Urbantech File No. 06-233ph2

**Re: Response to 3rd Engineering Submission Comments
(in support of Draft Plan approval)
Orangeville Highlands Phase 2
Town File No.: 51/10 & OPZ 5/10**

RE: ORANGEVILLE HIGHLANDS – TOWN COMMENT RESPONSE LETTER

Sight Triangles

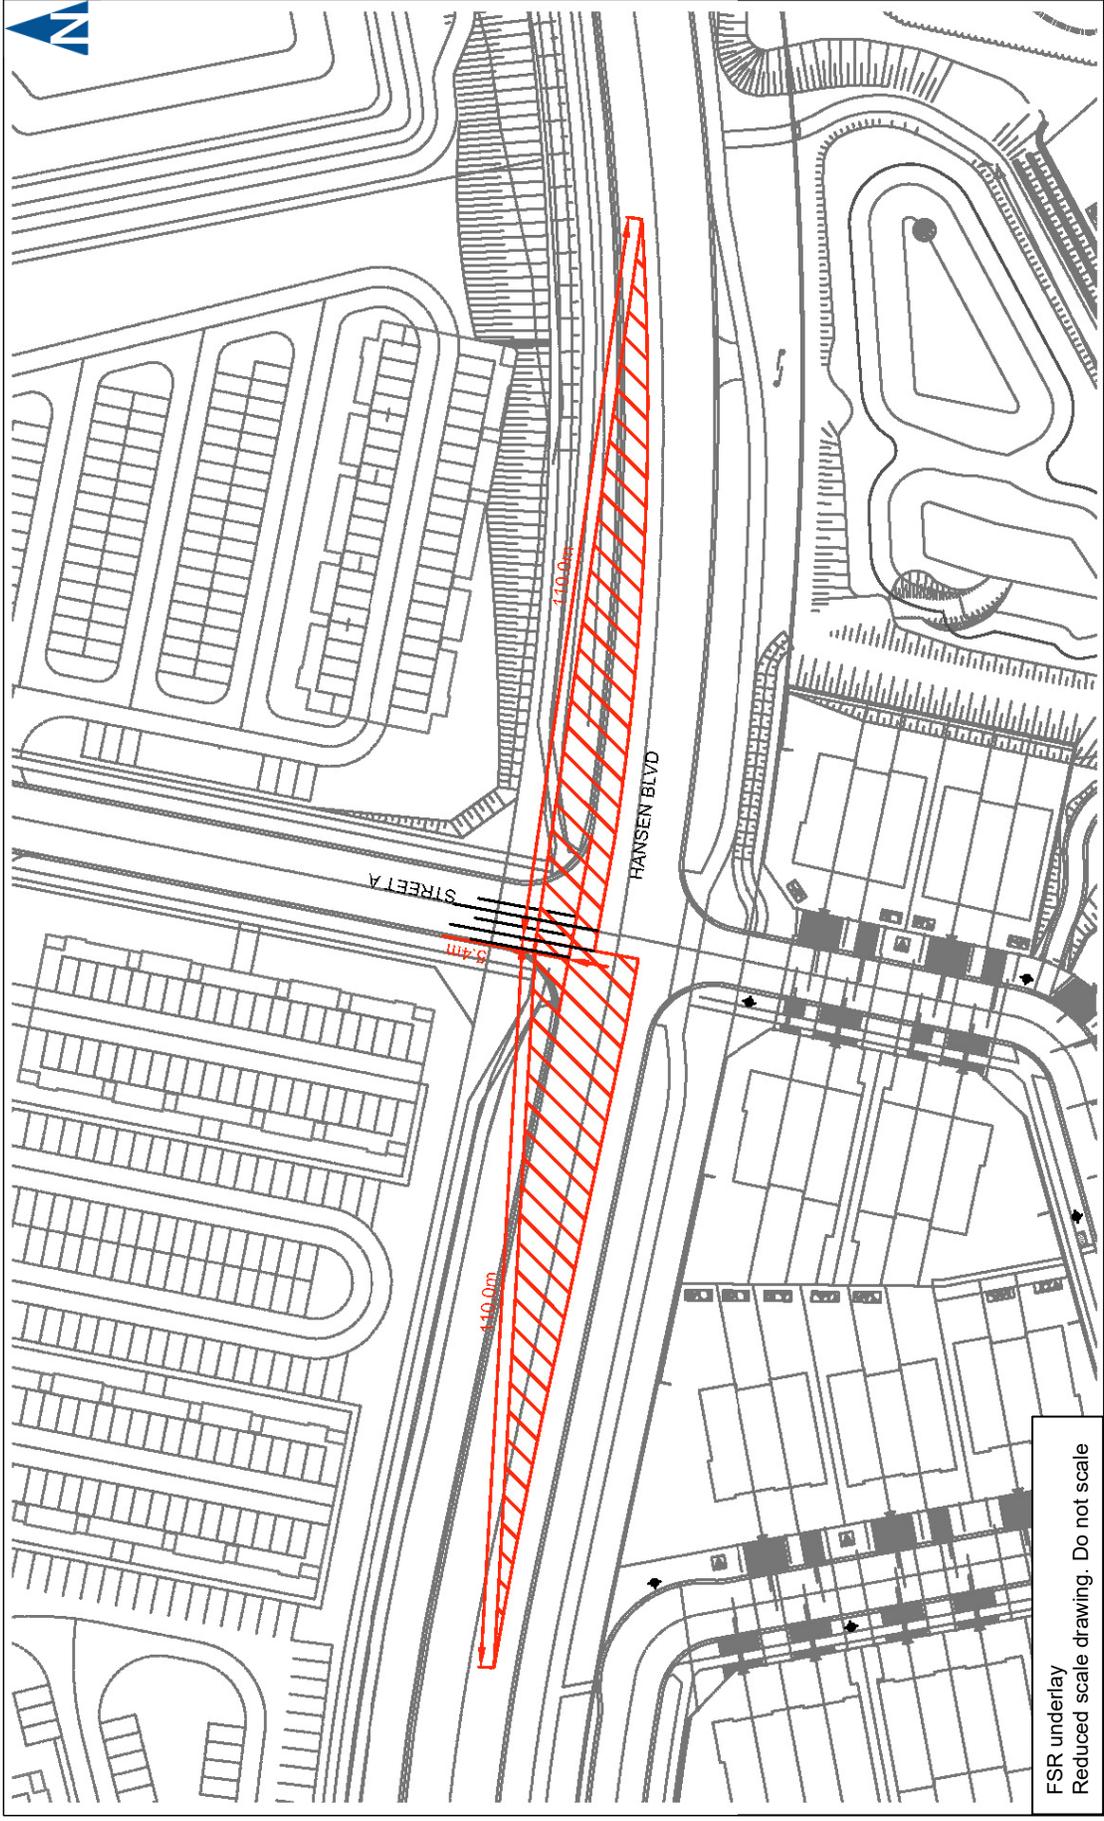
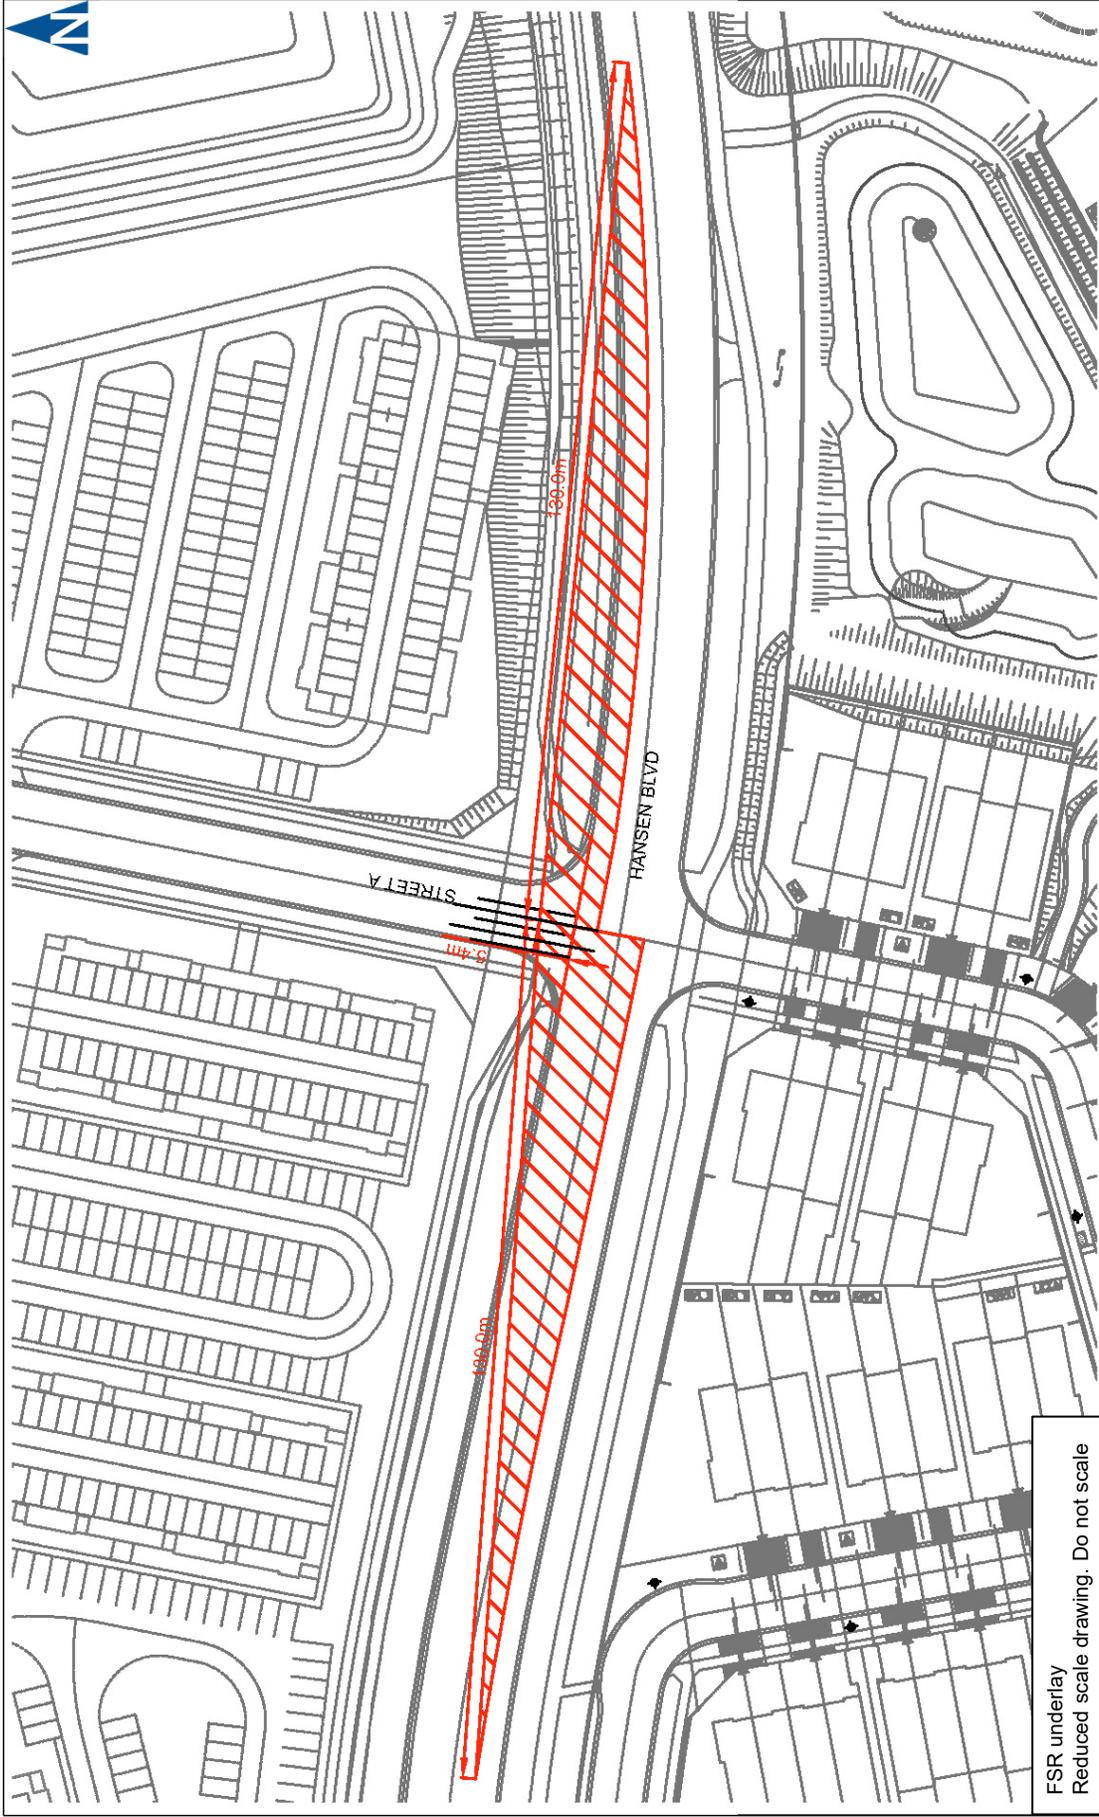
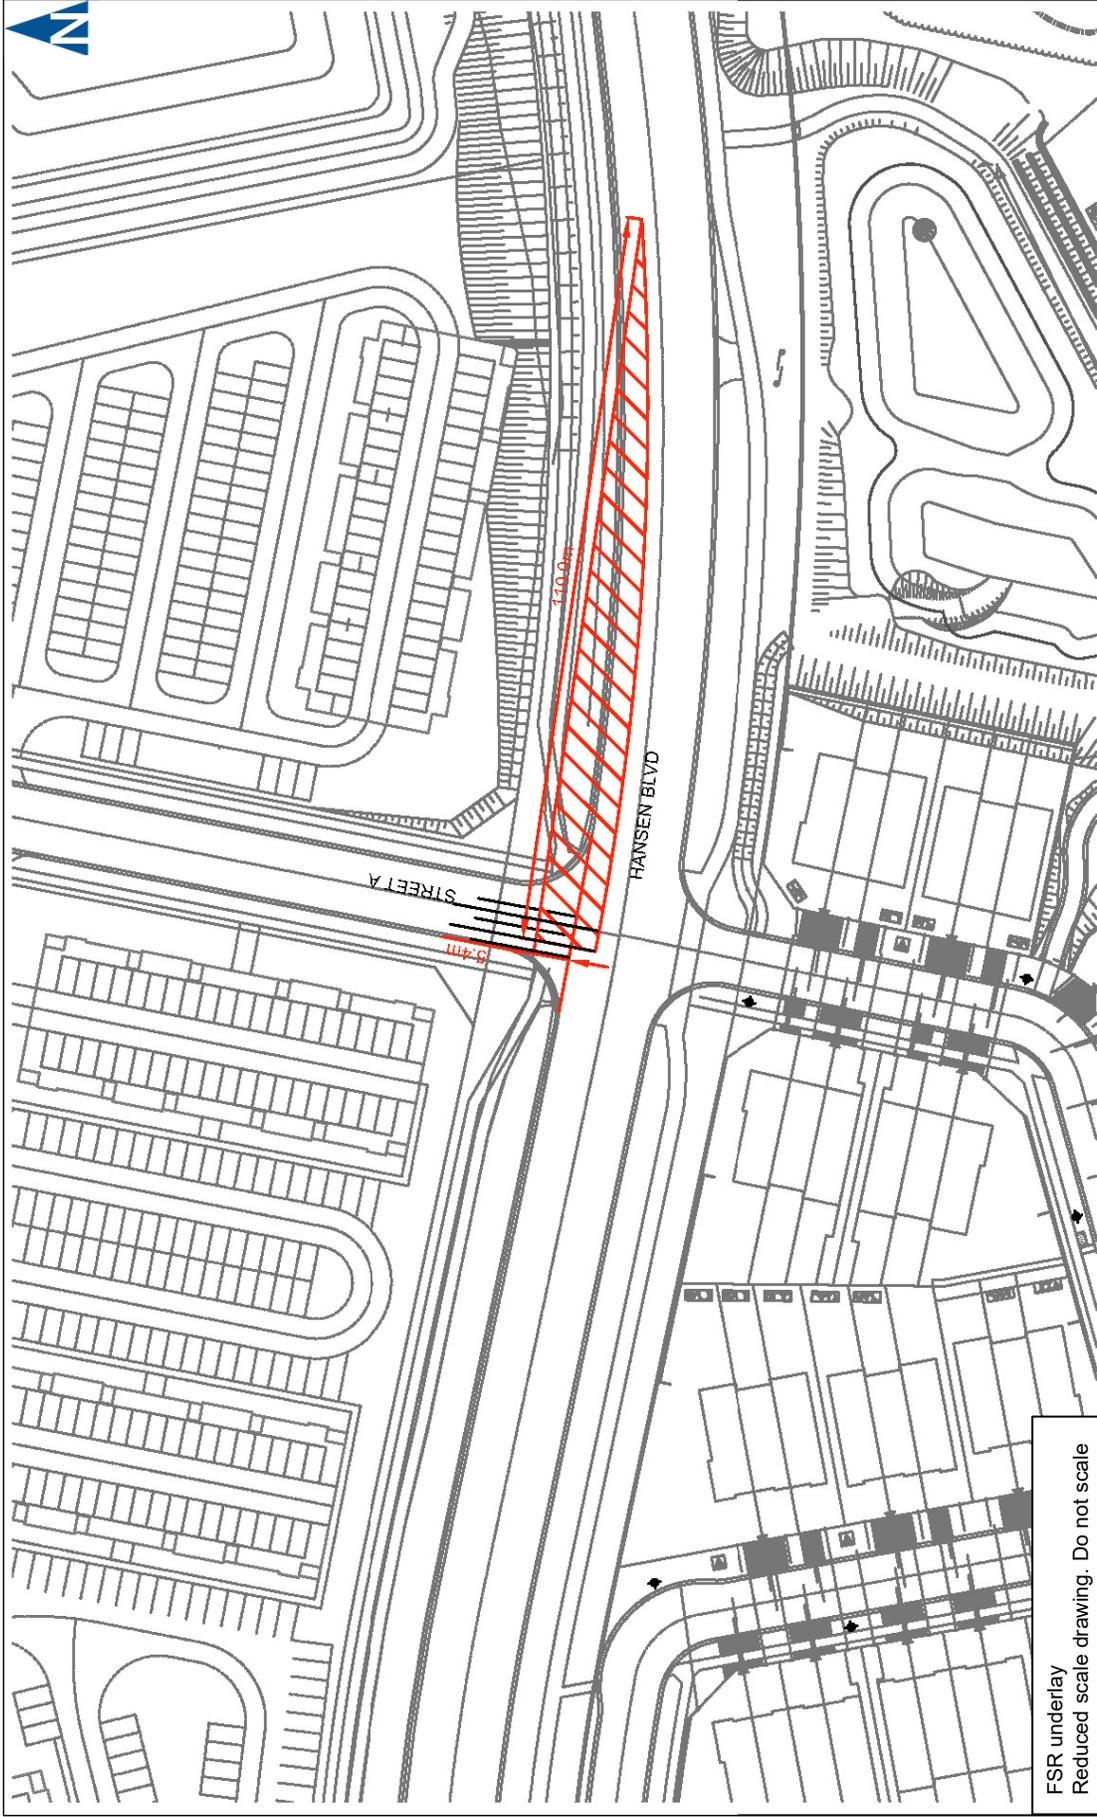
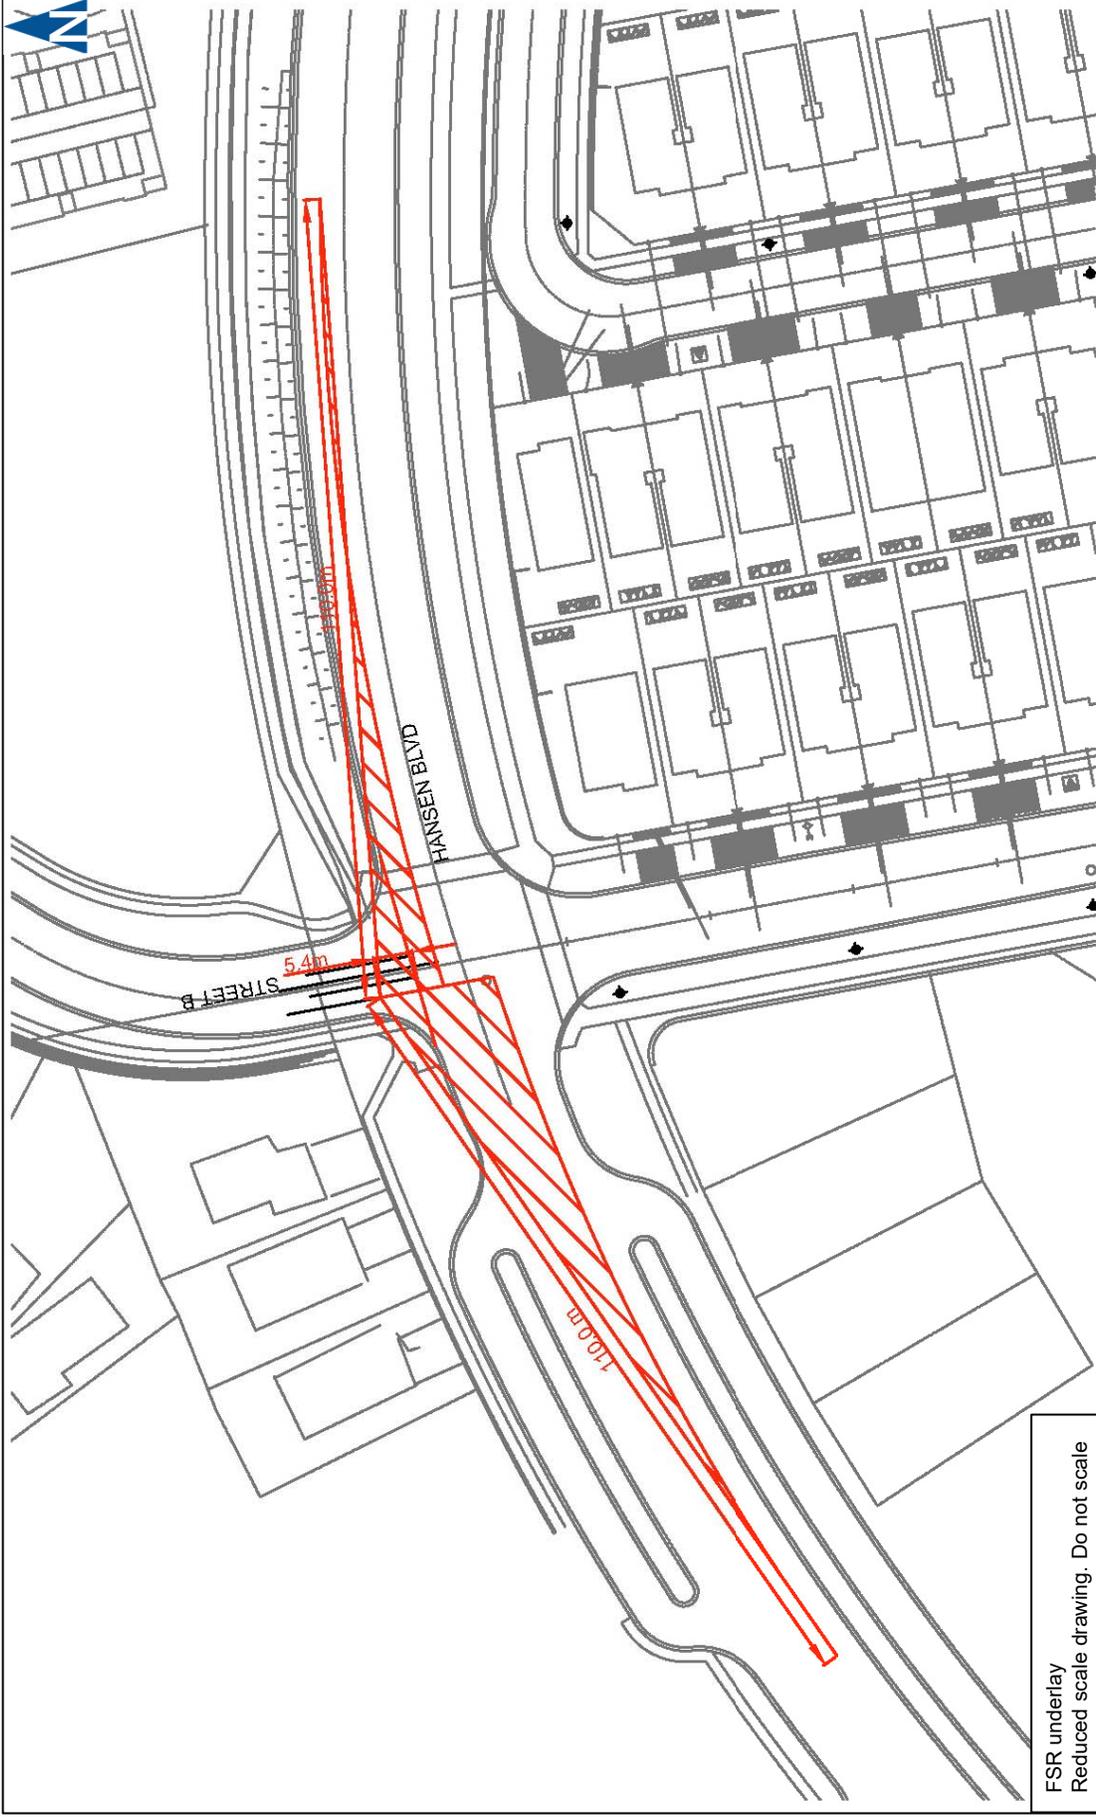
- Both intersections into the development will be signalized in accordance with the traffic impact study. The calculations for site line requirements have not been provided. Please provide the required calculations indicating that proper site distance and visibility triangle has been provided for stop controlled intersections. Refer to the TAC Manual Section 2.3.3.5, copy attached.

“Both intersections into the development will be signalized in accordance with the traffic impact study. The calculations for site line requirements have not been provided. Please provide the required calculations indicating that proper site distance and visibility triangle has been provided for stop controlled intersections. Refer to the TAC Manual Section 2.3.3.5, copy attached.”

Please refer to **Attachment 4** for a detailed sight-line analysis prepared by Paradigm.

The Transportation Association of Canada (TAC) Geometric Design Guide for Canadian Roads referred to by the Town is the September 1999 version. The TAC Geometric Design Guide for Canadian Roads June 2017 manual is the current version and follows best practices. Based on the TAC 2017 manual¹, the following sight distance requirements apply for a design speed of 10 km/h over the posted speed limit (60 km/h):

Attachment A contains the sight triangles for Street A and Street B based on TAC Geometric Design Guide for Canadian Roads June 2017.

The sight triangles for Street A and Street B are contained within the existing Hansen Boulevard right-of-way. The proposed daylight triangles to the Street A and Street B approaches are satisfactory. No changes to the block layout are recommended.
